ADDENDUM NO. 2

**George Washington Carver State Office Bldg.,
Replace Multiple Electronic Systems
1616 Missouri Blvd.,
Jefferson City, MO 65109
PROJECT NO. 02427-01**

SPECIFICATION CHANGES:

DRAWING CHANGES:

2 Level 1 Fire Alarm New Work Plan
3/32" = 1'-0"

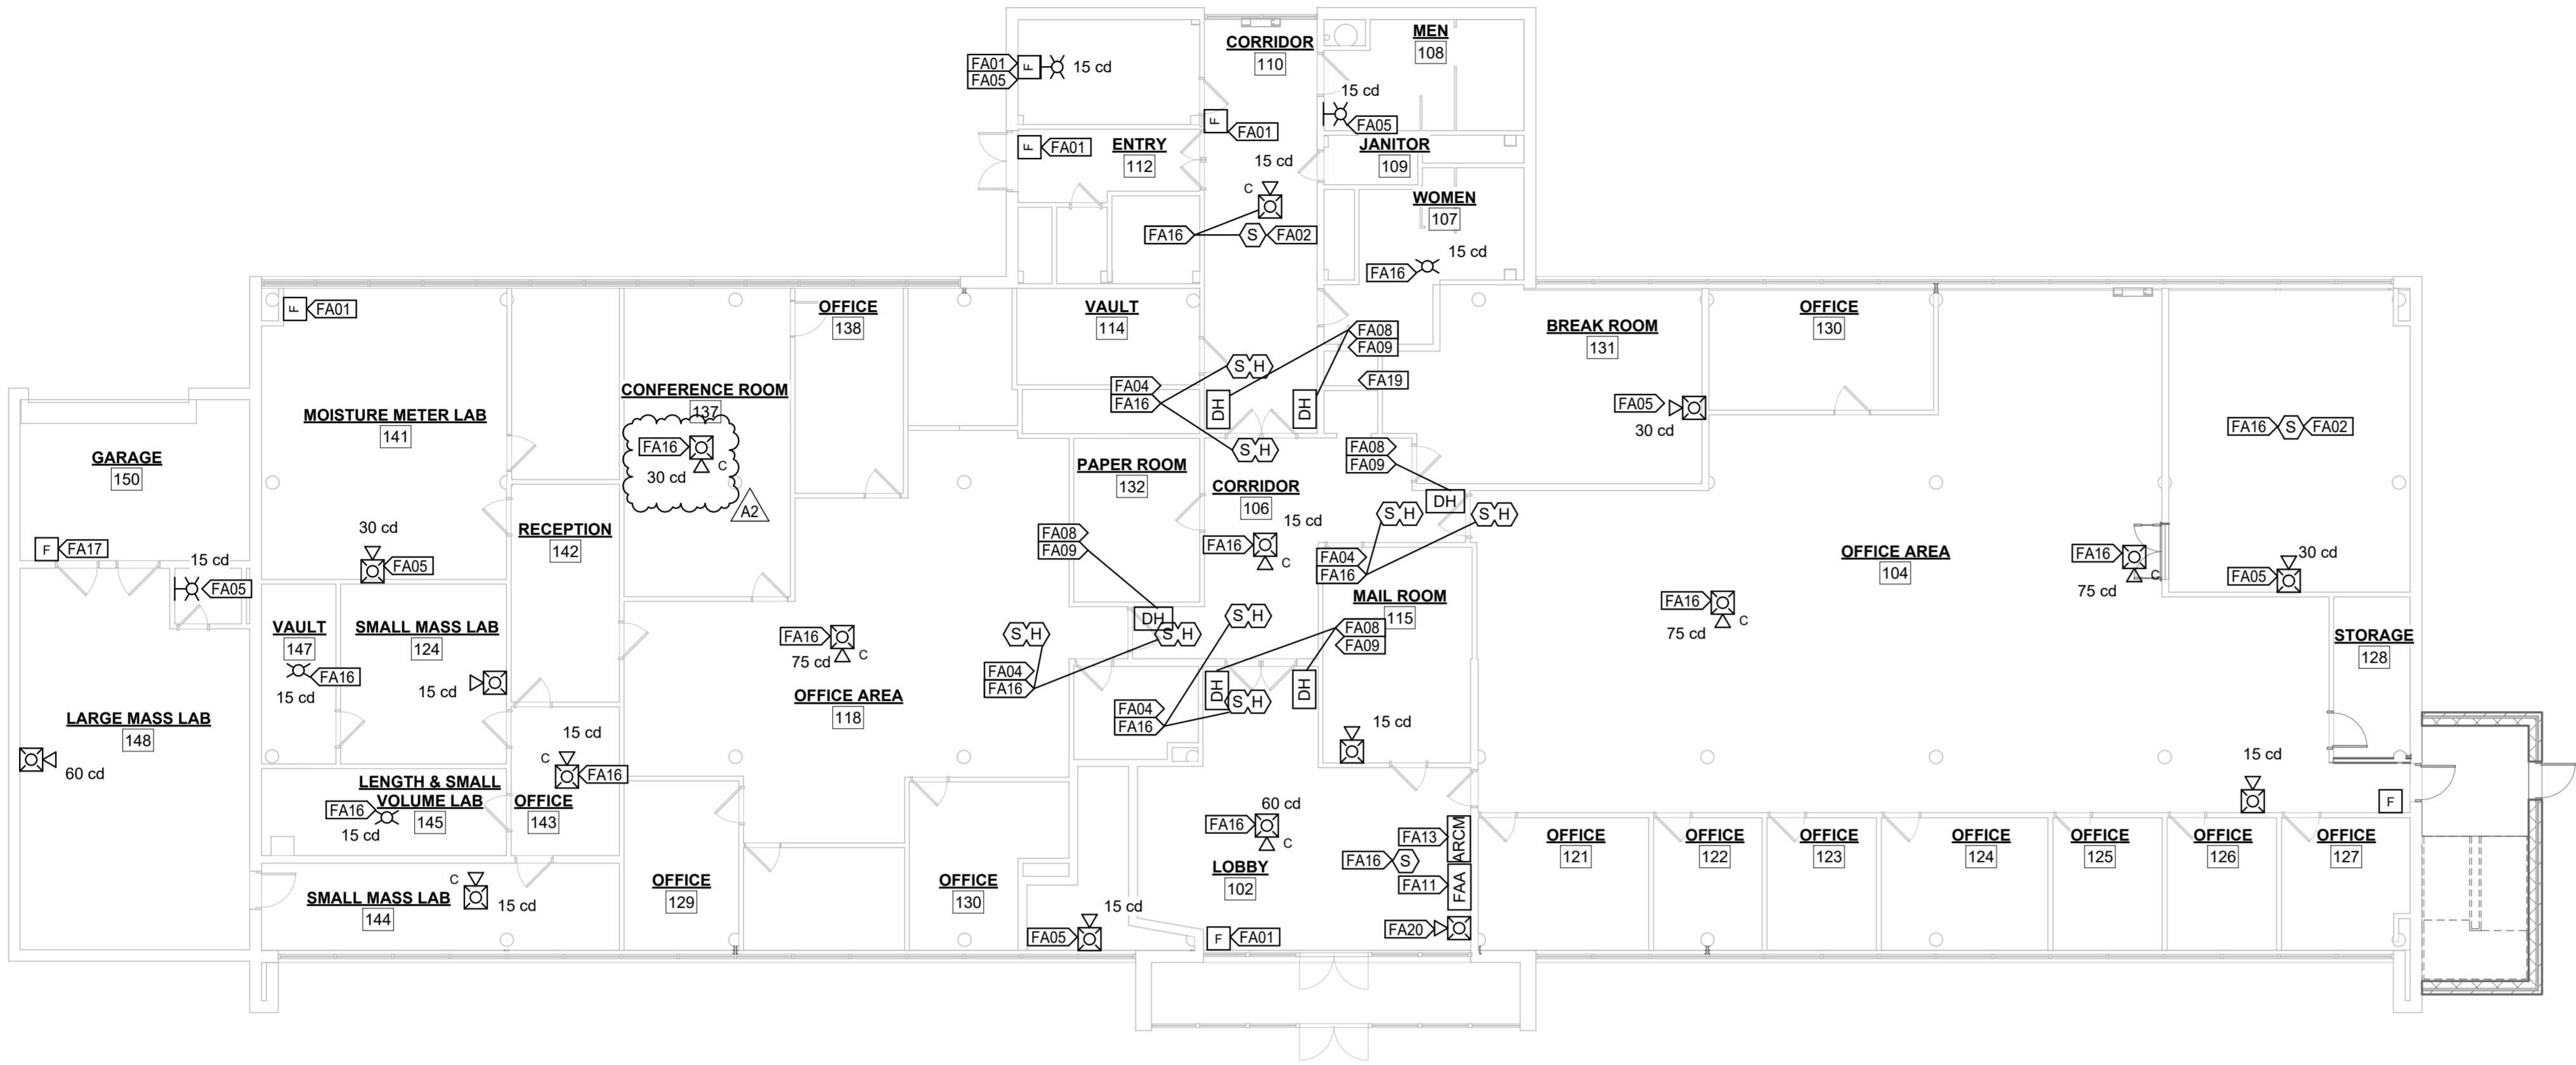
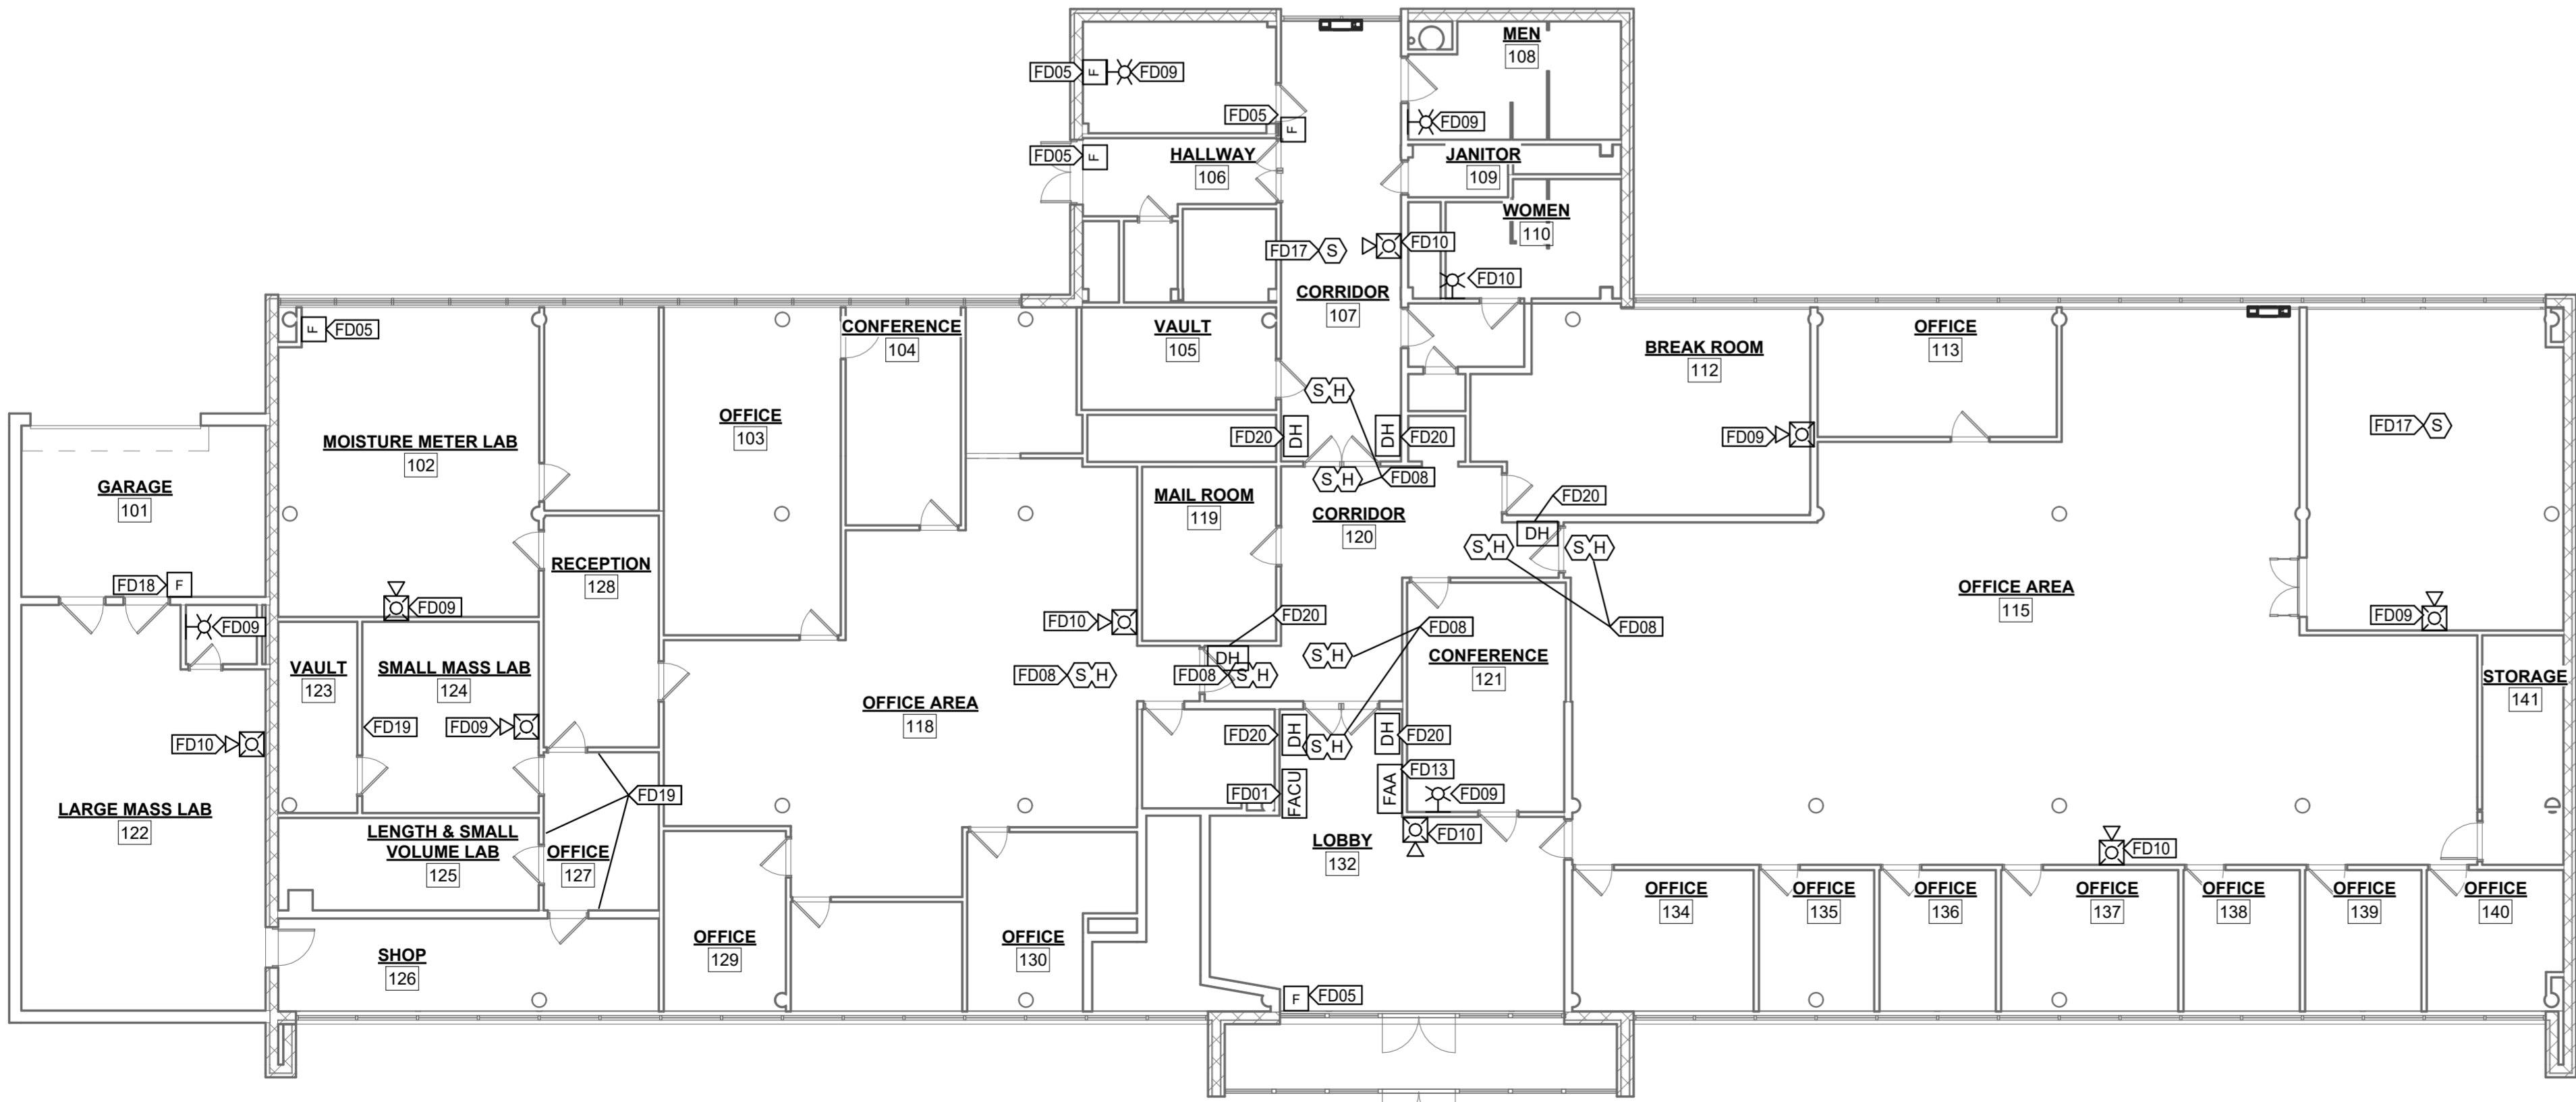
Drawing FA101 – Fire Alarm Plans, Level 1; added ceiling-mounted horn/strobe in Conference Room 137. Added

Question 2: We believe a strobe is needed in the conference room on the first floor.

Question 3: Will the state provide a phone line for the Area of Refuge system to call out to the fire department?

Response 2: A strobe has been added to revised drawing FA101.

Response 3: Keynote FA13 on revised drawing FA101 was modified to provide additional information about phone line work by contractor and by owner.

2 Level 1 Fire Alarm New Work Plan - Warehouse
1/16" = 1'-0"

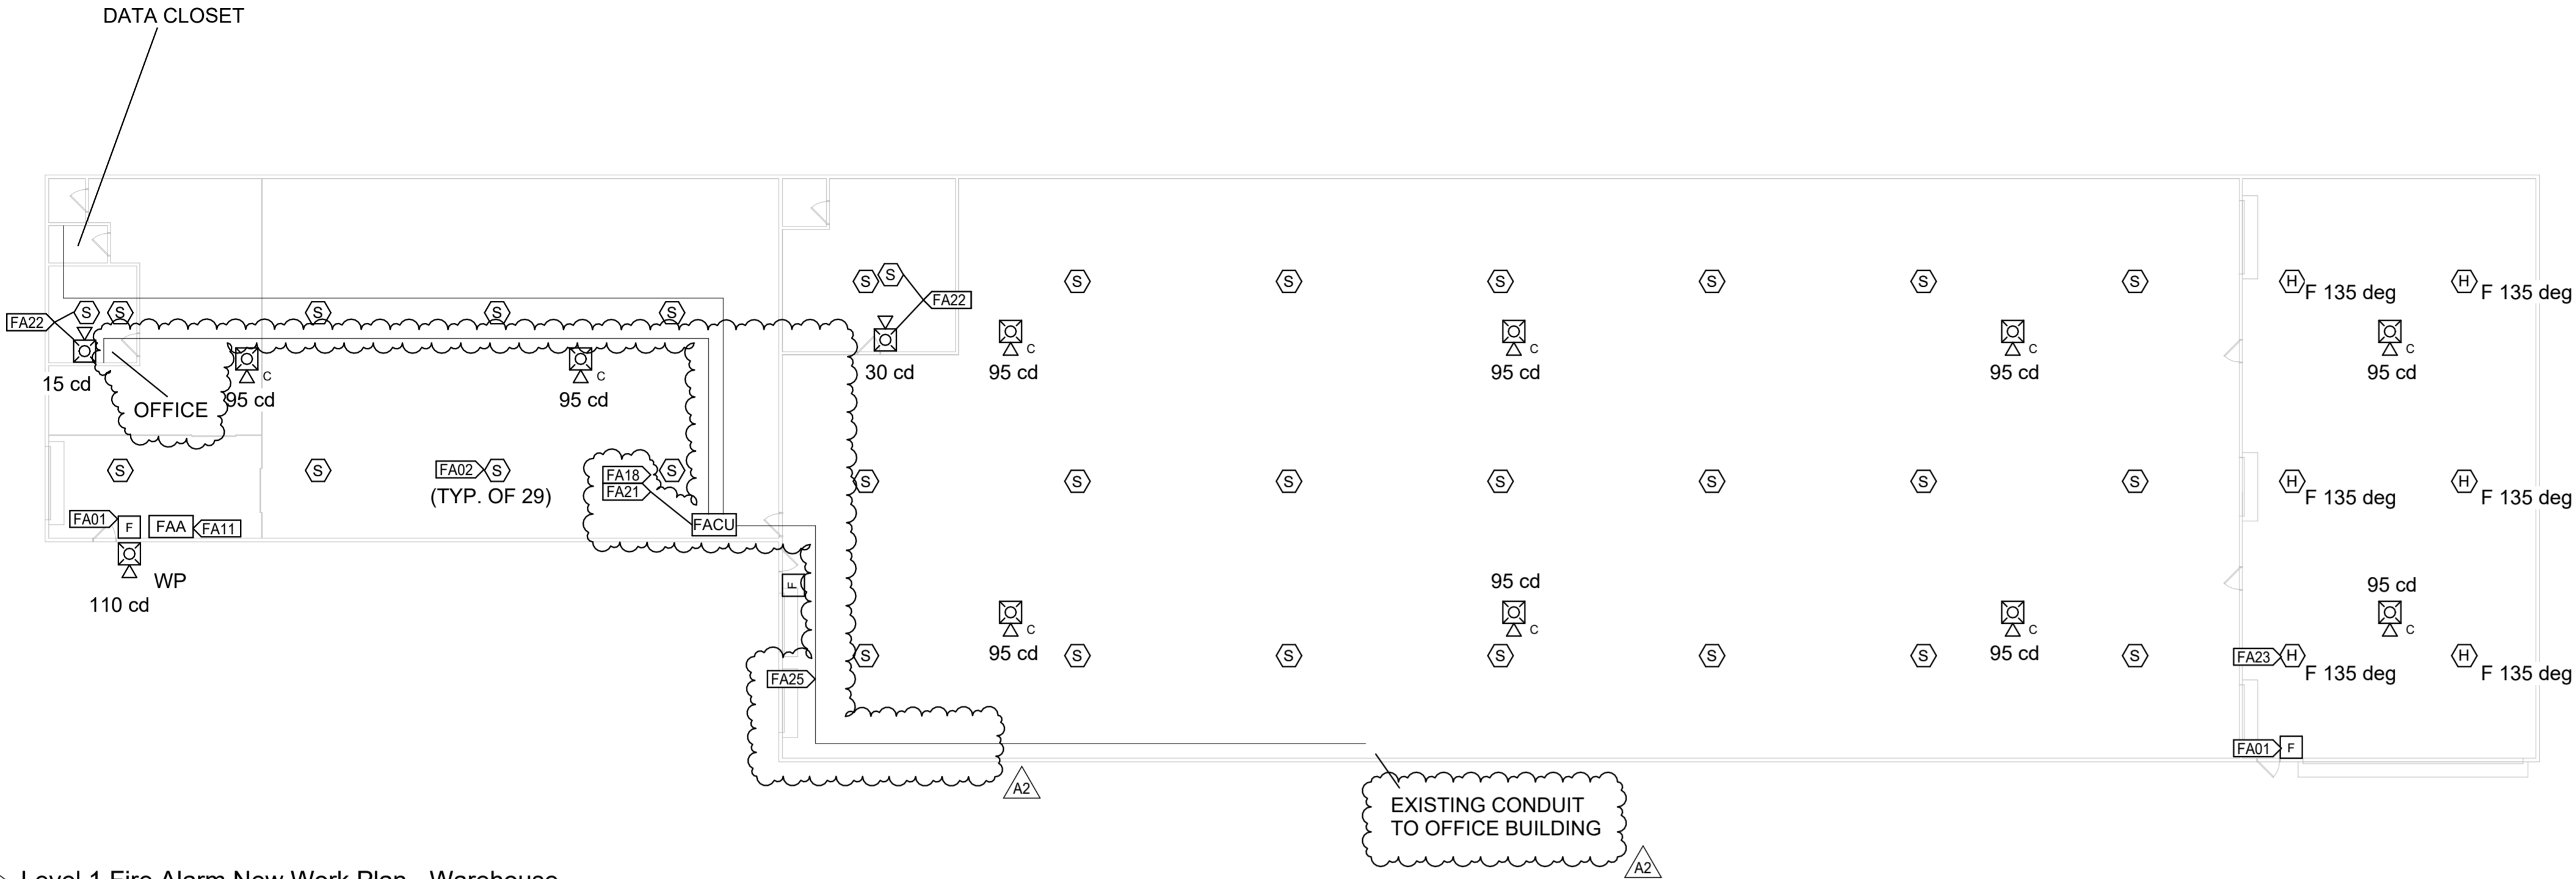
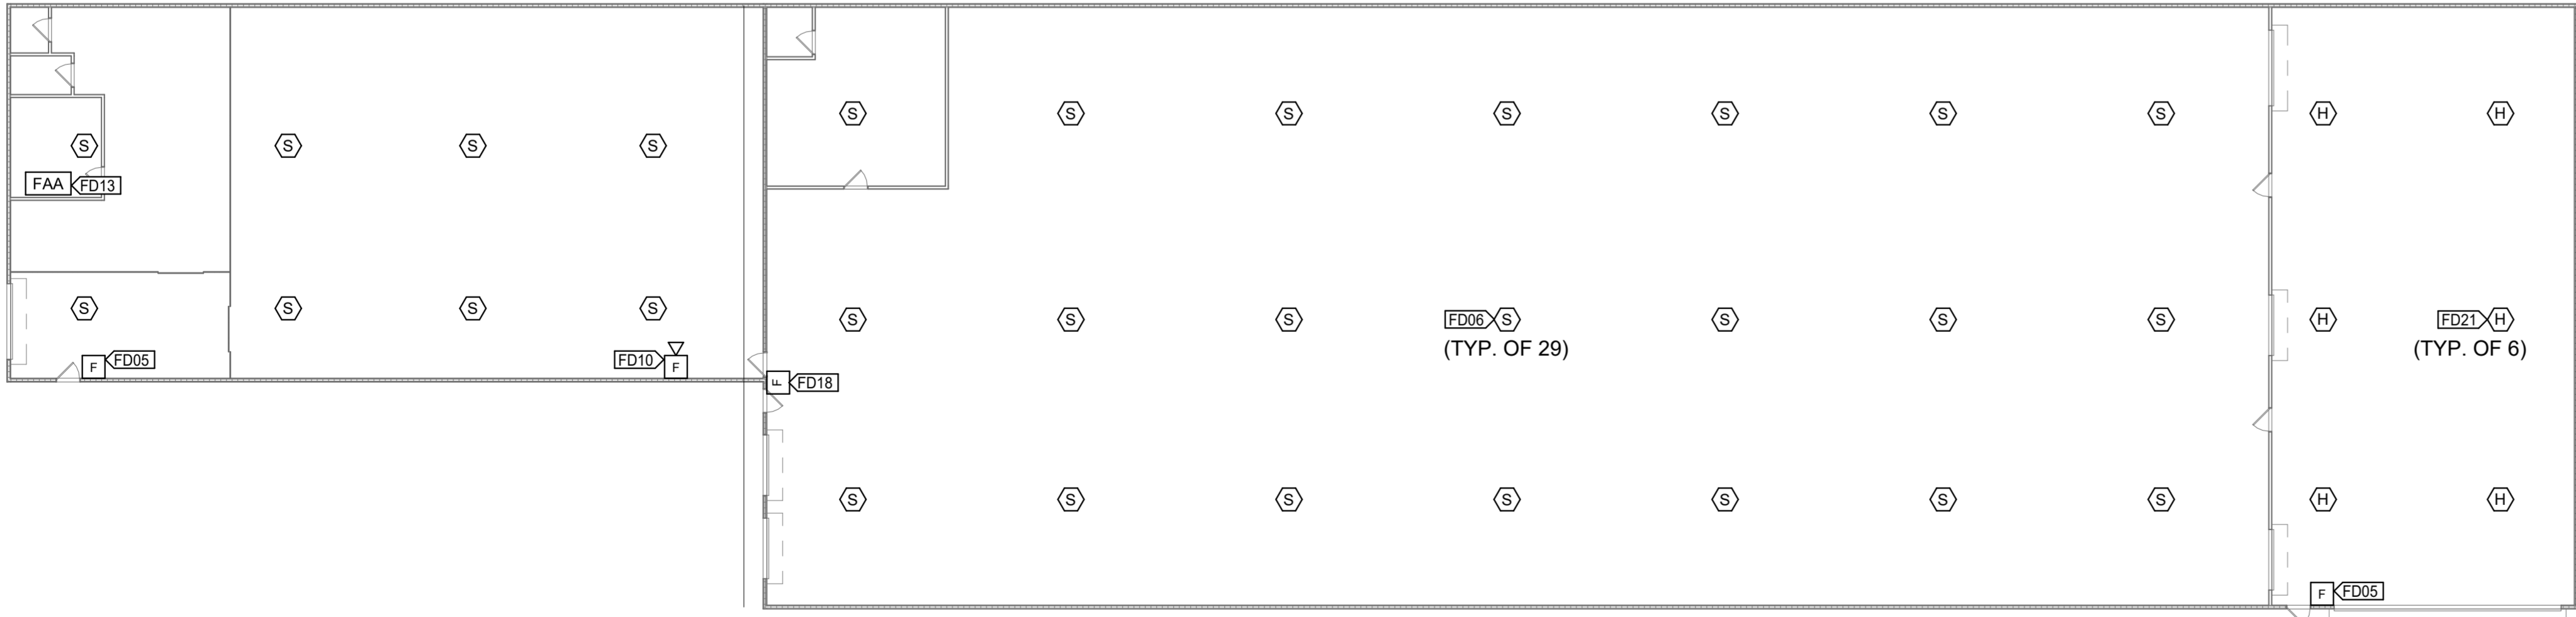
Drawing FA111 – Fire Alarm Plans, Warehouse; relocated fire alarm control unit and dialer to west portion of building and revised power circuiting accordingly. Added note clarifying fire watch requirements.

Question 1: Please clarify how the fire watch is to work. Are we responsible for the fire watch or if the state is going to take care of that?

Response 1: A note clarifying fire watch requirements in the warehouse which will be continuously occupied during construction has been added to revised drawing FA111.
